Product Change Notification

■ Product List Business 430-18044_IT3,IT5 Series Packaging specification change

Packaging specification change

Drawing

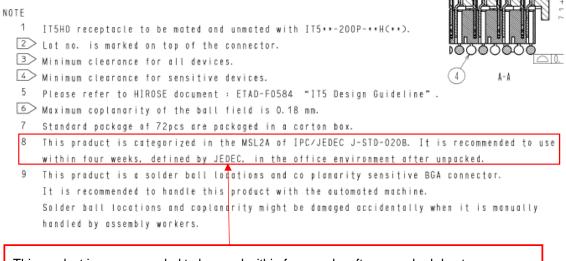
The label attached on the vacuum packing will be changed as follows since MSL 2A is not applicable. (We are going to change from January 6, 2019.)

Note in the drawing will be changed as follows.

This product is recommended to be used within four weeks after unpacked due to the possibility of oxidation of BGA.
